CD-2023-264

**Subject: Federal Cell Facility Application: Responses to the Director's Request for Information –
DRC-2023-078530**

Appendix B: Federal I Cell Facility Engineering Drawings

"CLIVE" FACILITY
 ENERGYSOLUTIONS SITE FACILITIES
 GROUNDWATER MONITORING WELLS
 CLIVE, UTAH

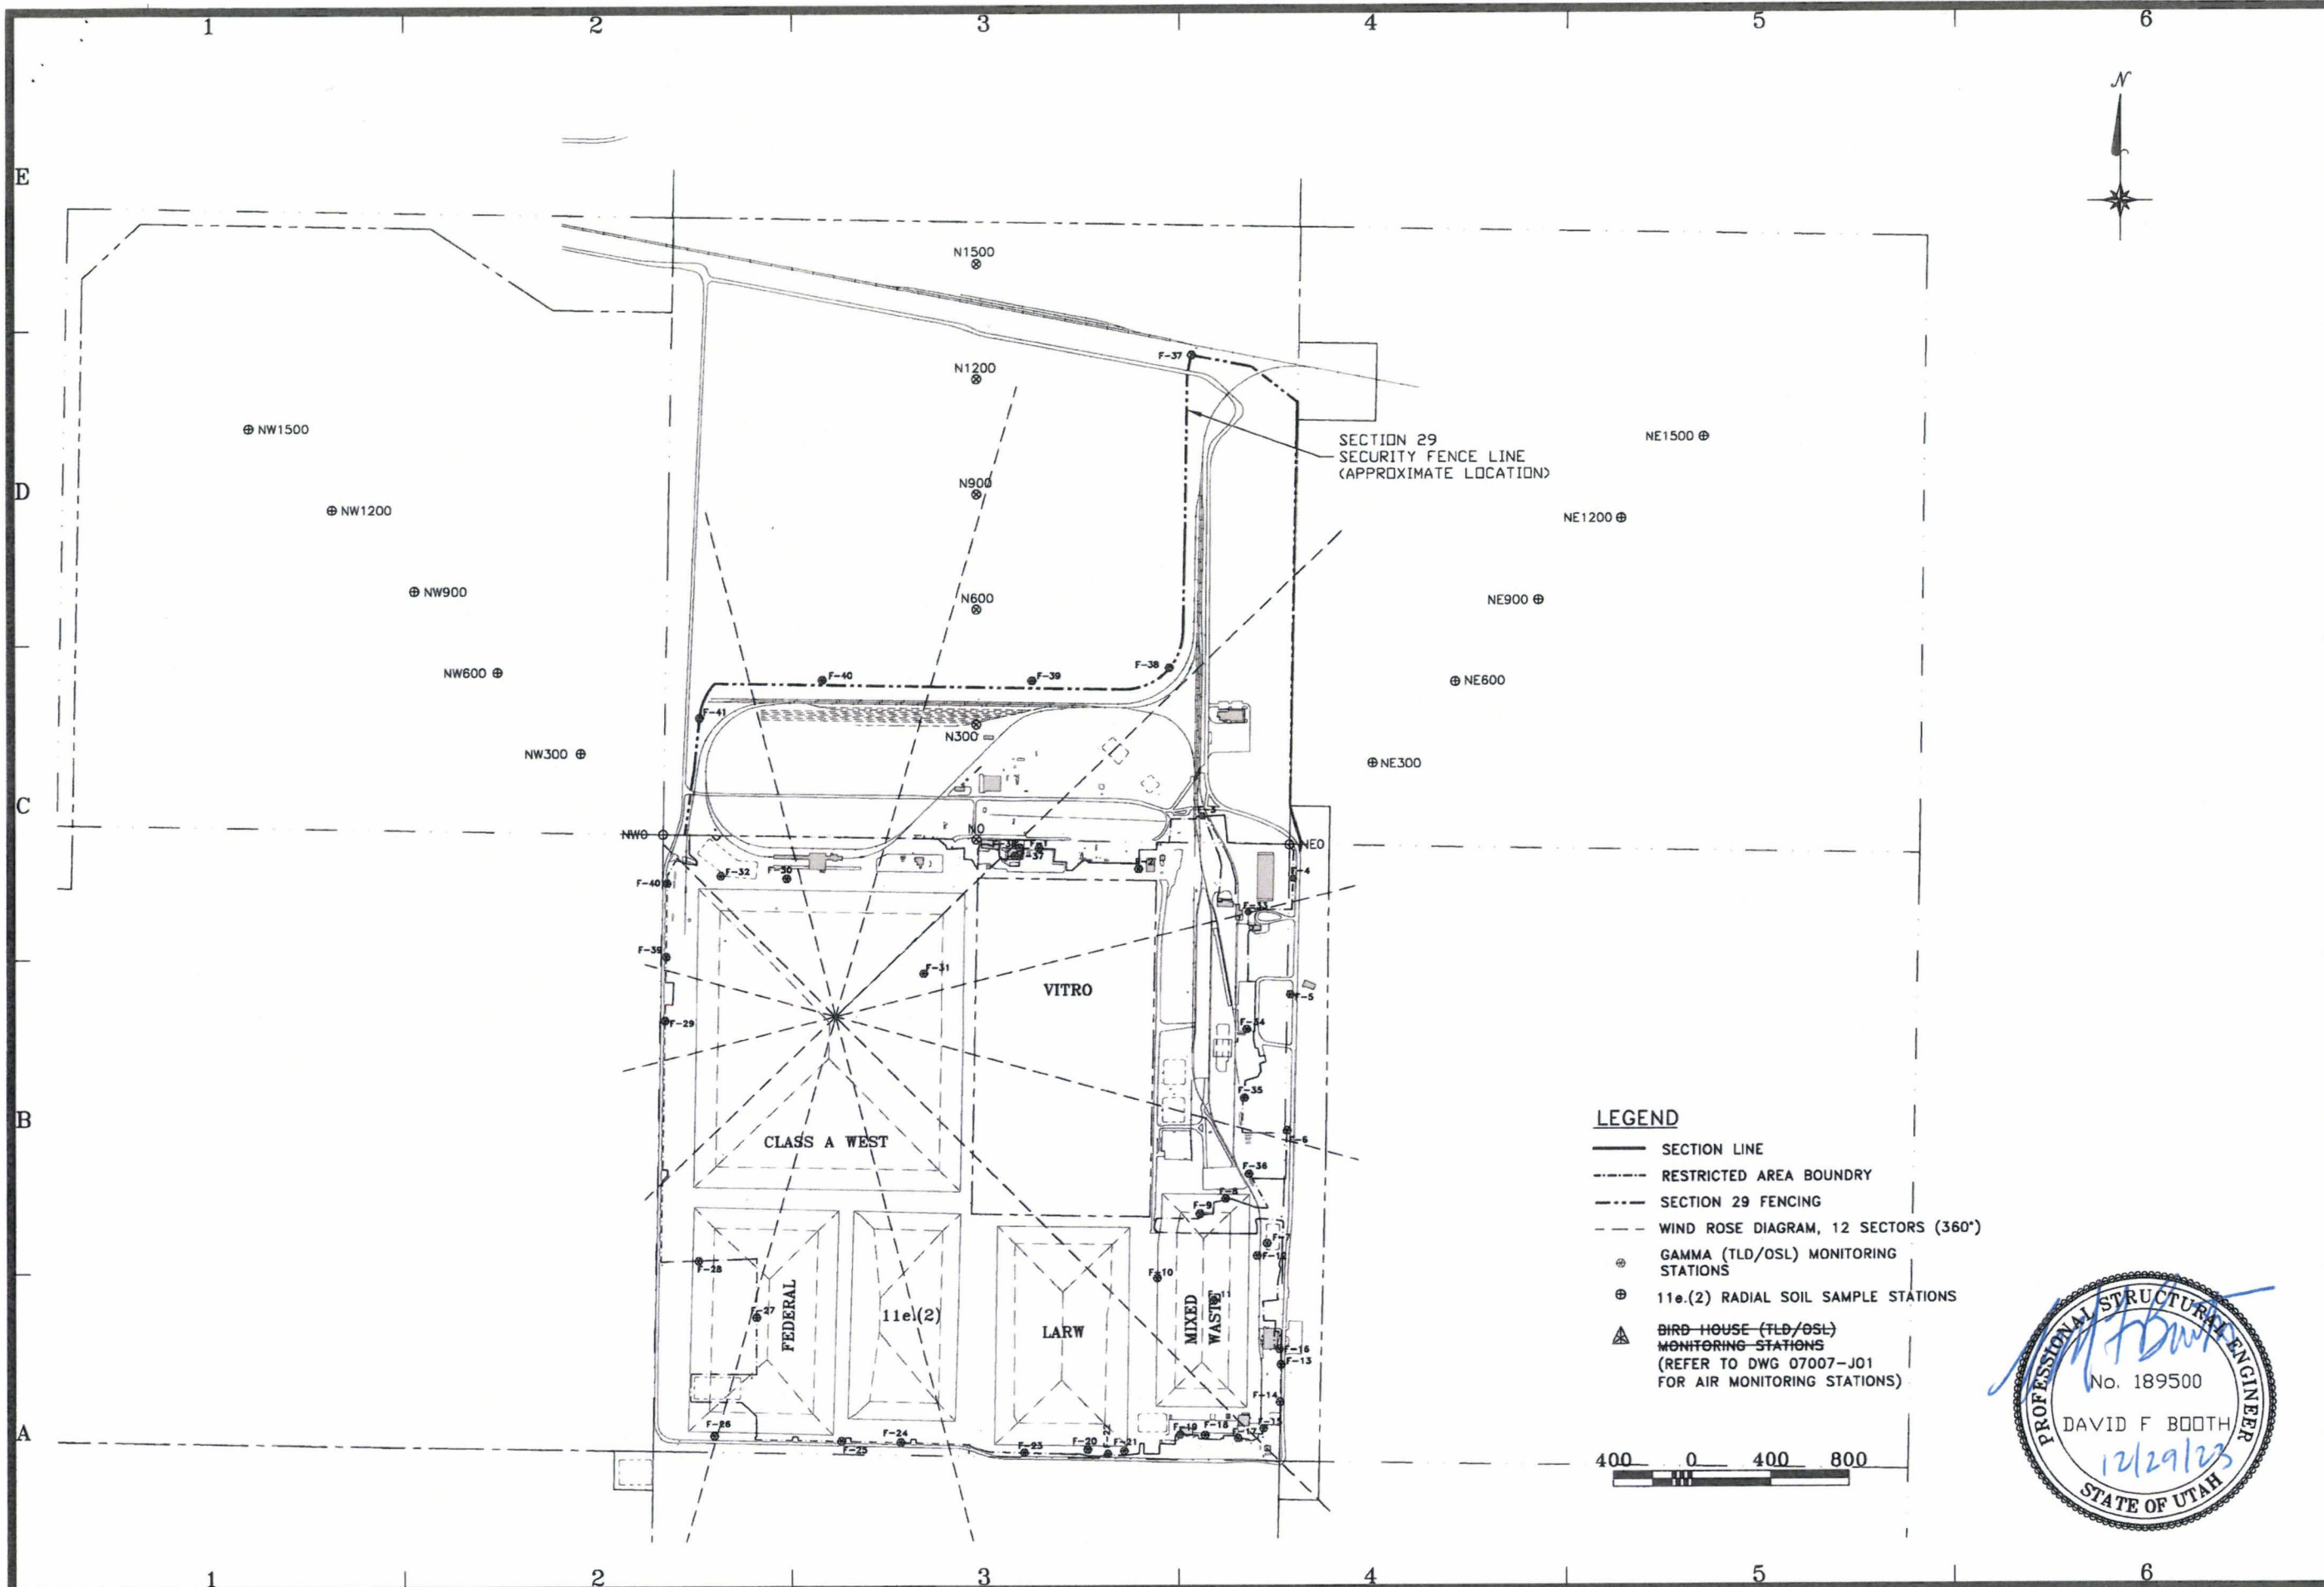
B-5: A groundwater monitoring well to the Southeast corner (above GW-136) is not labeled correctly. Please revise to reflect correct labeling.

The groundwater well label has been corrected on Engineering Drawing 07007-J02.

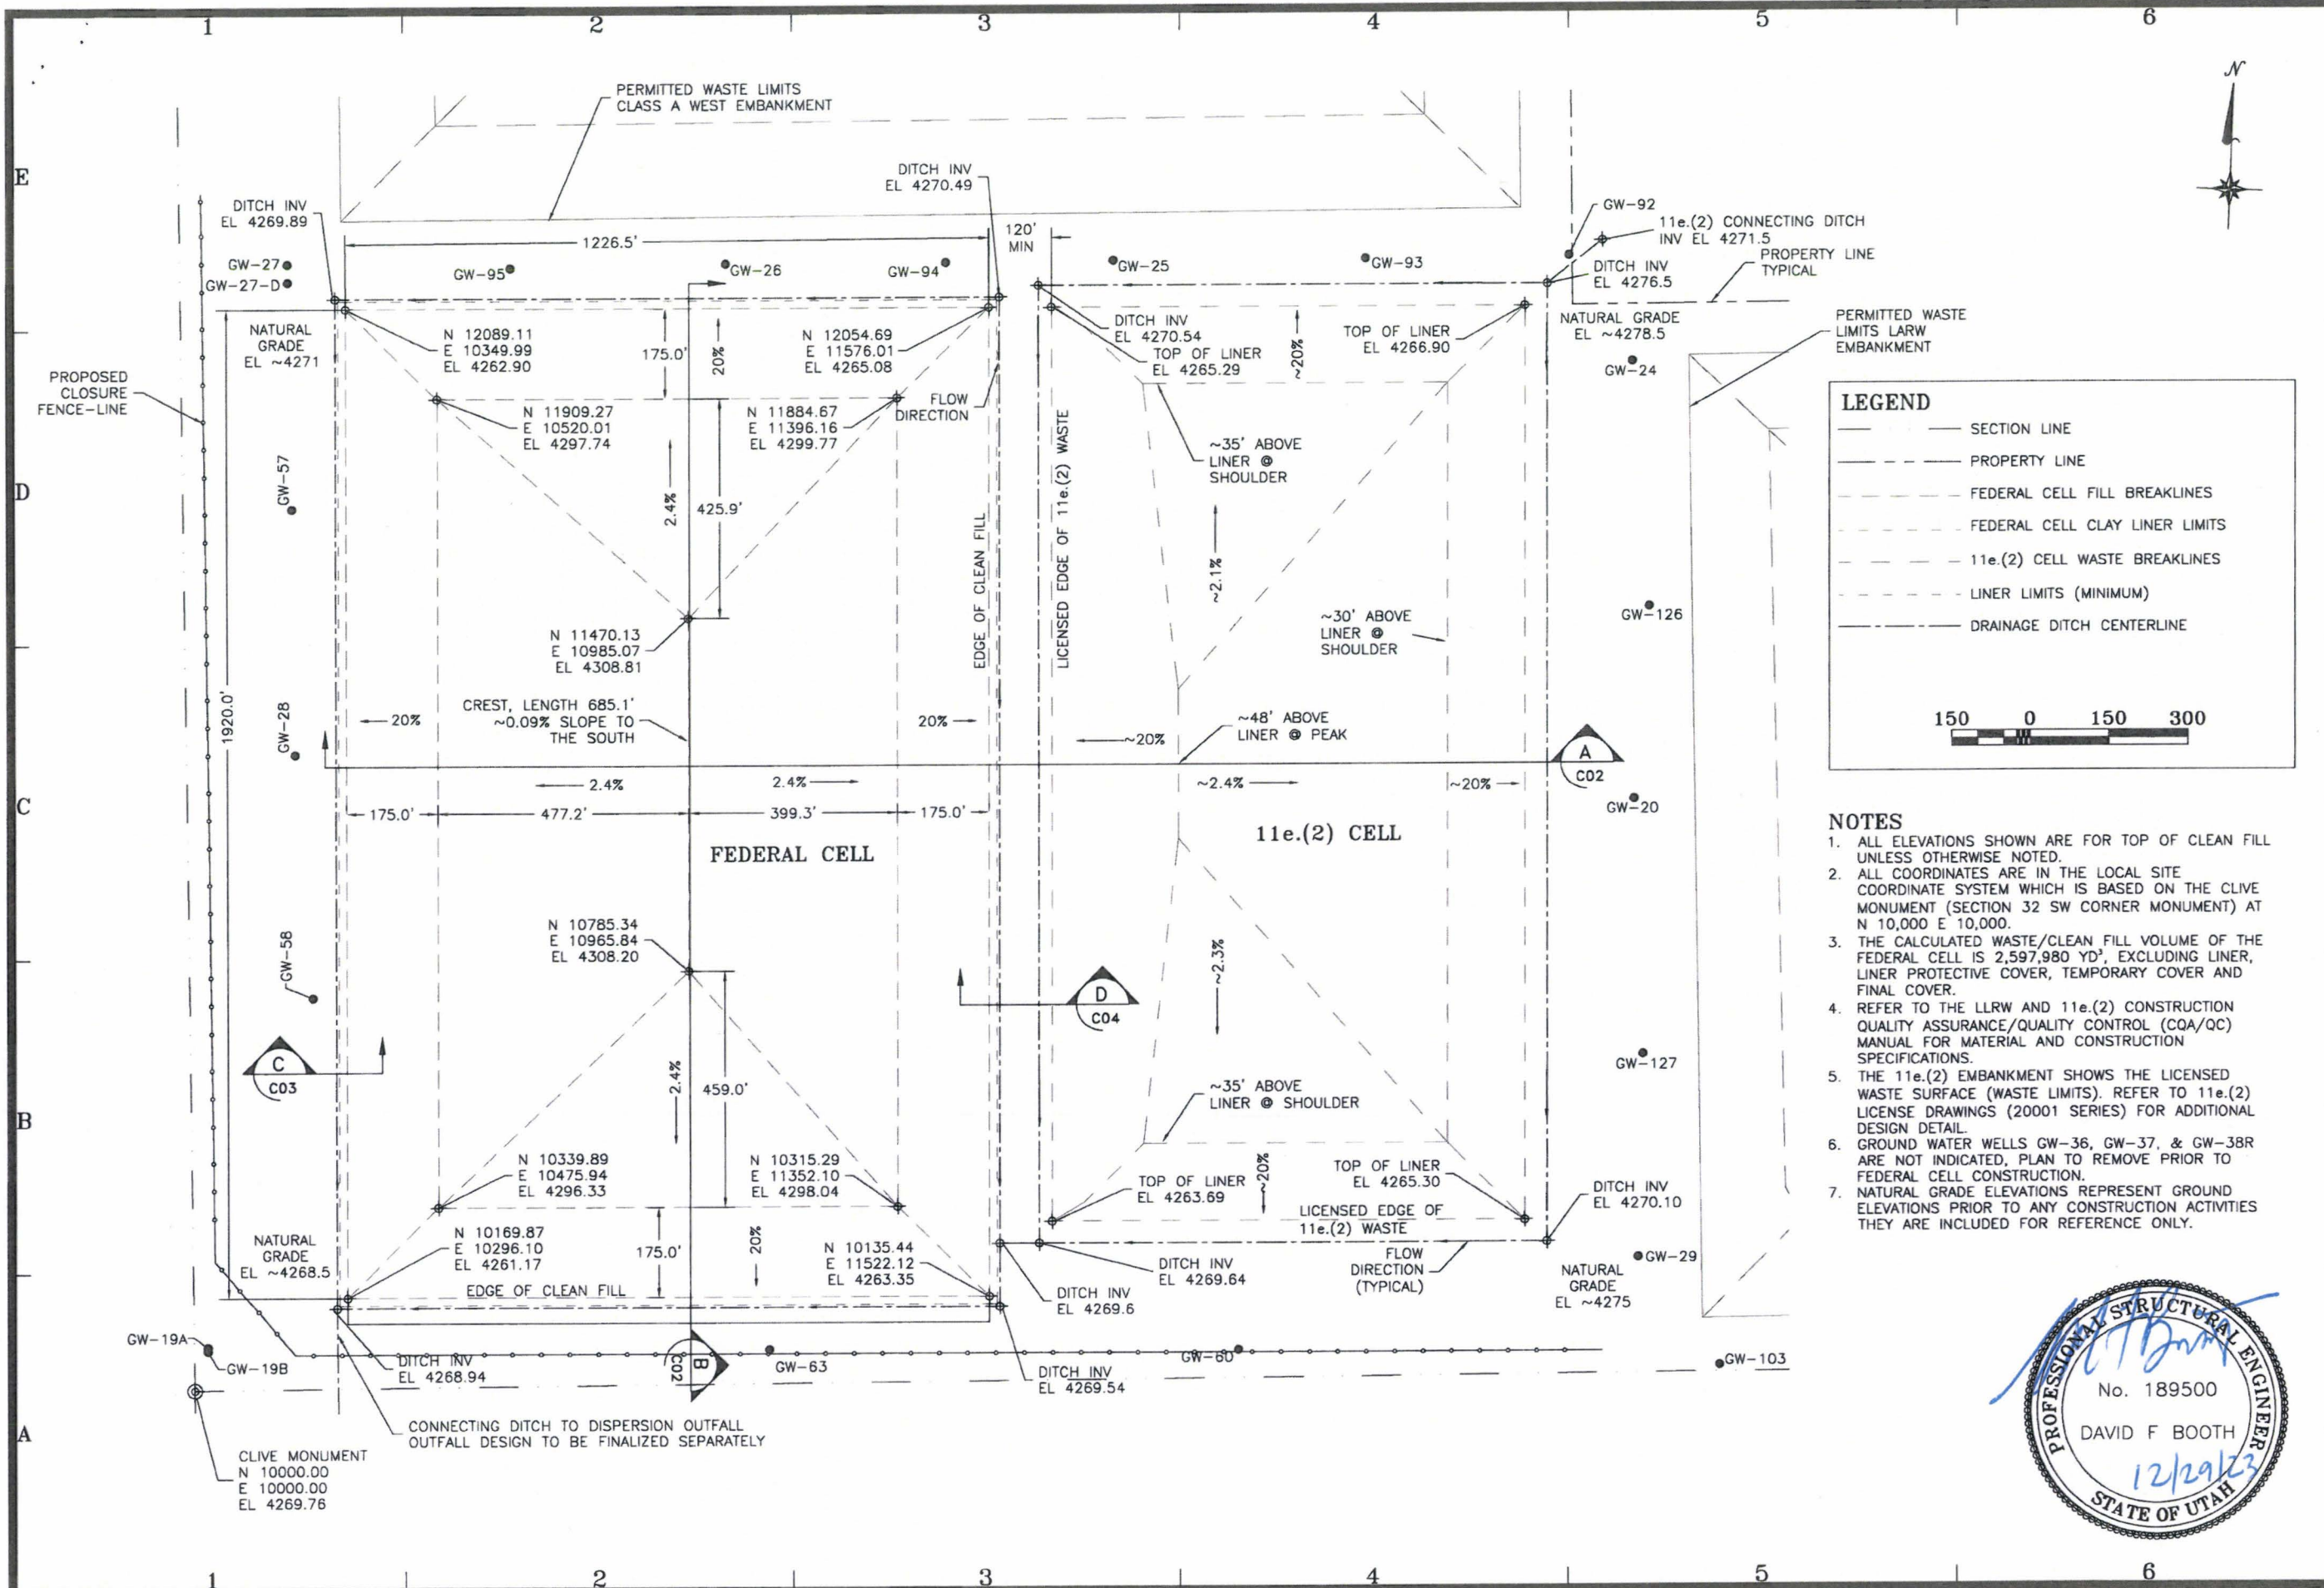
B-6: Green highlighting is noticeable on this sheet. If this coloring has significance, provide notes elaborating. Otherwise, please revise the sheet to remove green highlighting.

B-9: Please revise sheet to indicate the correct orientation of the North arrow.

The licensed embankment outlines are placed correctly on Engineering Drawing 07007-J03. Similarly, the divisions of the scale marker are sized correctly. The Clive Site Engineer elected to apply green highlight to the scale marker and embankment licensed outlines as a location aid to the reader. The U.S. Nuclear Regulatory Commission (NRC) is silent in 10 CFR 61, NRC's NUREG-1999 and NUREG-1200 on a prohibition of the use of a colored scale marker or license outlines to assist readers. Additionally, no such prohibition has been promulgated in Utah Administrative Code R313-25. Even so, the green highlighted boundary, scale, and embankment outlines have been adjusted to black on Engineering Drawing 07007-J03 in response to the director's preference.

The use of lines on Engineering Drawing 07007-J03 has been unified and included in the Legend.

The depiction of north has been corrected on Engineering Drawing 07007-J03.

14004
C01

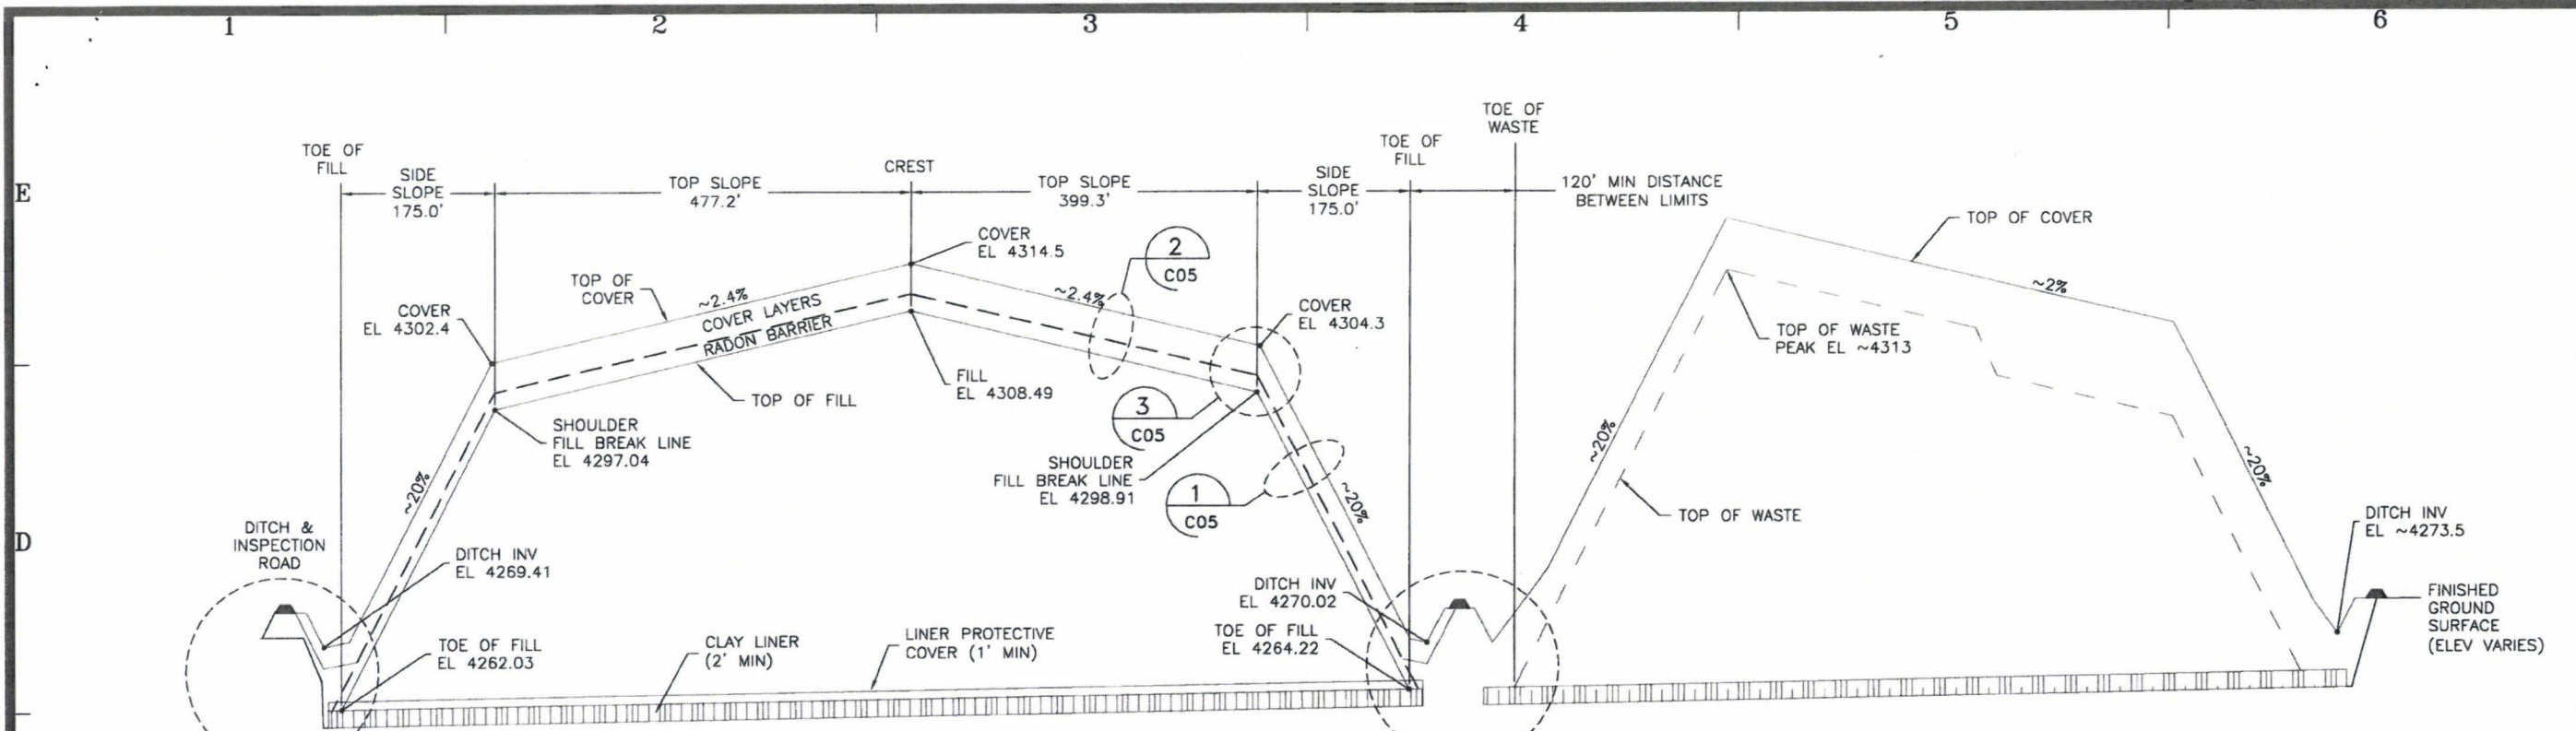
B-13: Please elaborate with background information on "Clive Monument" or provide text language that gives clarity. It is unclear as to the datum used to establish this monument as a control point.

B-14: Does the calculated volume include the cover system and/or the clay liner? This conflicts with the language in Note (1) of this sheet in that information displayed is related to "CLEAN FILL." Expand to explain and/or breakdown this parameter.

B-17: Please provide clarity on what these dimensions indicate.

B-19: *The term "NATURAL GRADE" is utilized in the plans. The elevations indicated appear to be elevations of the surrounding area; however, man-made infrastructure exists in these areas such as roads and berms. Please elaborate on the term "NATURAL GRADE."*

B-20: *The weight scale of the line for "LINER LIMITS (MINIMUM)" does not appear to be consistent with what is observed on the plan view. Please revise Legend item to be consistent as presented in the plan.*

B-22: *The centerline of the ditch appears to go off to the Northeast corner of the 11e.(2) cell. Please provide details on this anomaly.*

B-23: *There appears to be a leader within the “DRAINAGE DITCH CENTERLINE” throughout this entire plan view. Please revise sheet to either remove the leader or explain significance.*

The Clive Monument was established as a positioning central point to support a separate radioactive material license granted prior in 1994 and is not being adjusted to support the proposed Federal Cell Facility. However, the legacy datum used to establish the Clive Monument as the positioning original control point has been summarized on Engineering Drawing 14004-C01 in response to the director's preference.

Clean Fill is defined in the Federal Cell Facility Construction Quality Assurance/Quality Control Manual. The description of calculated volumes has been clarified and expanded on Engineering Drawing 14004-C01 in response to the director's preference.

The dimensions noted on Engineering Drawing 14004-C01 has been clarified.

The term "Natural Grade" was established and has been in use on director-approved Engineering Drawings since 1988. Even so, the terminology has been clarified on Engineering Drawing 14004-C01 in response to the director's preference.

The lines on Engineering Drawing 14004-C01 accurately display the appropriate geographic boundaries. The U.S. Nuclear Regulatory Commission (NRC) is silent in 10 CFR 61, NRC's NUREG-1999 and NUREG-1200 on a prohibition of the use of various line weight scales in Engineering Drawings. Additionally, no such prohibition has been promulgated in Utah Administrative Code R313-25. Even so, the legend of Engineering Drawing 14004-C01 has been revised to be consistent with the weight scale for the lines presented in the plan.

The centerline anomaly identified in Engineering Drawing 14004-C01 has been clarified.

Even though the Clive Facility Site Engineers elected to add a leader within the drainage ditch centerline, the ditch centerline is accurately displayed on Engineering Drawing 14004-C01. The U.S. Nuclear Regulatory Commission (NRC) is silent in 10 CFR 61, NRC’s NUREG-1999 and NUREG-1200 on a prohibition of the use of additional illustration leaders. Additionally, no such prohibition has been promulgated in Utah Administrative Code R313-25. Even so, the leaders in question have been removed from Engineering Drawing 14004-C01 in response to the director’s preference.
